• **DRIVEABILITY—5.4L 2V—IDLE-AIR BYPASS FLOW INDUCED WHISTLE** • **ENGINE—5.4L 2V—IDLE-AIR BYPASS FLOW INDUCED WHISTLE** • **NOISE—IDLE-AIR BYPASS FLOW INDUCED WHISTLE—VEHICLES EQUIPPED WITH 5.4L 2V ENGINE ONLY**	**Article No. 02-10-8**

FORD: 1999-2002 E SERIES, EXPEDITION, F-150, SUPER DUTY F SERIES

Figure 1 - Article 02-10-8

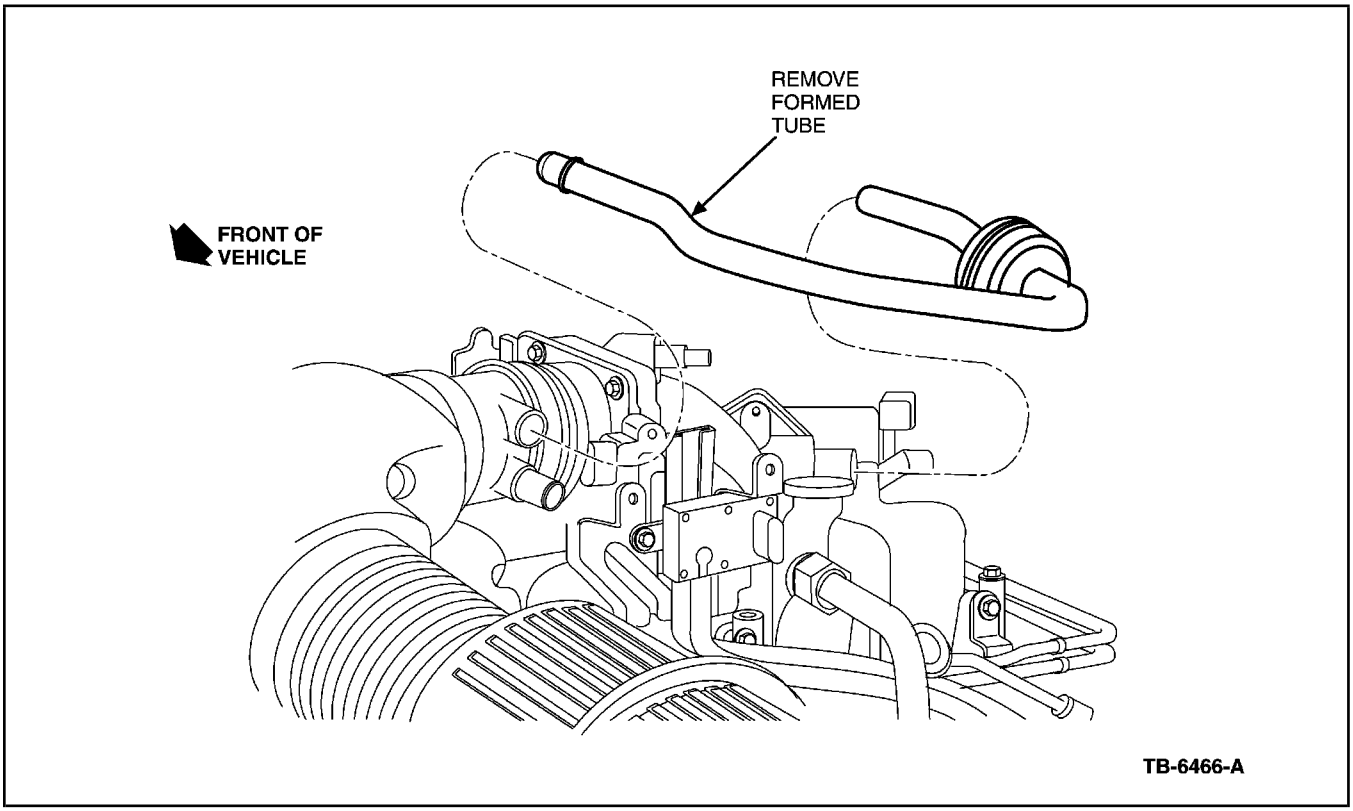
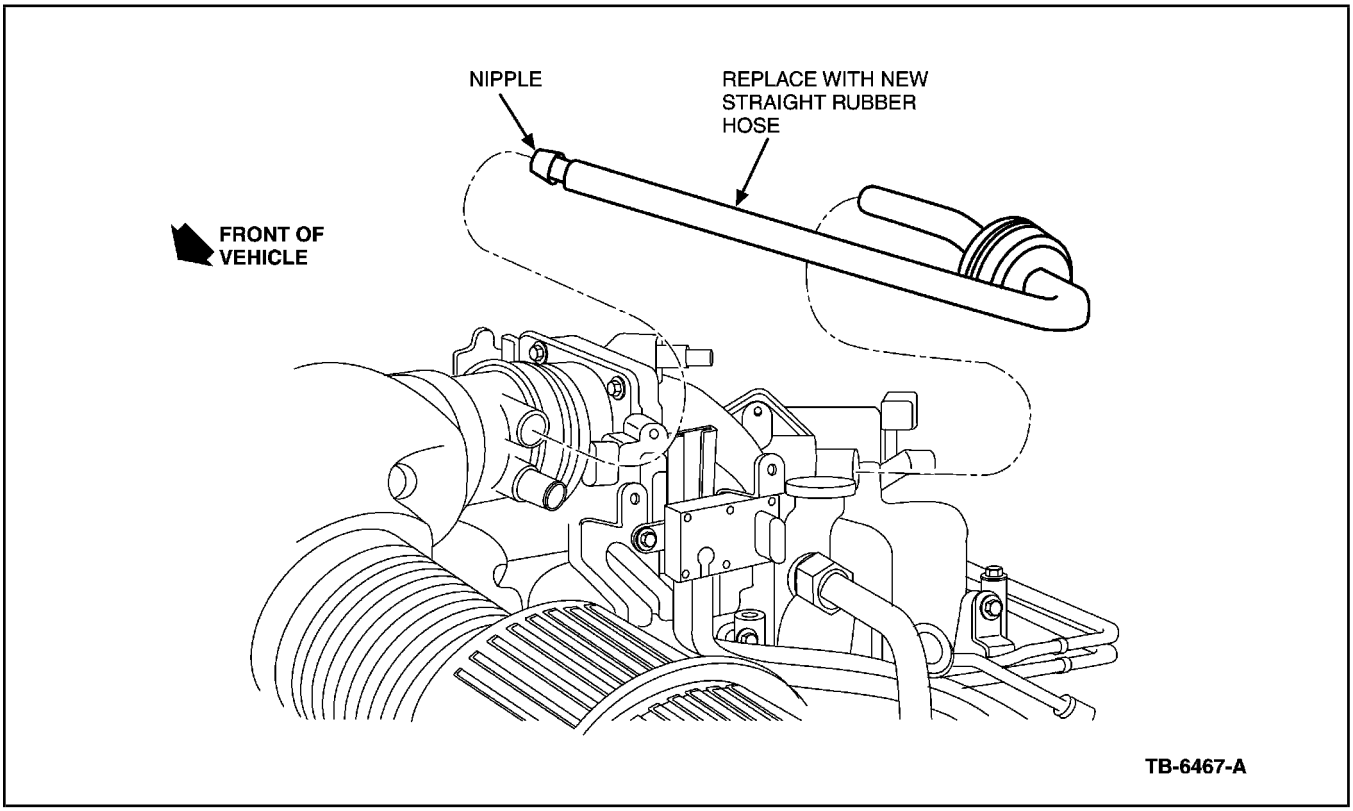
Some vehicles equipped with the 5.4L 2V engine may exhibit a “whistling” noise from the formed nylon tube in the idle-air bypass flow circuit. This may be caused by air flow passing through the sharp bend radius of the original tube assembly.

Remove and replace formed nylon tube with the Nipple And Hose Assembly 2L1Z-9W548-AA. This action will correct the sharp bend in the tube. Refer to the following Service Procedure for details.

1. Remove the formed tube as shown (Figure 1).
2. Replace with Nipple And Hose Assembly with part 2L1Z-9W548-AA.
3. Connect nipple to the air-inlet zip tube and the free end connects to resonator as shown (Figure 2).
4. Ensure that there are no kinks in the rubber hose which could restrict air flow.
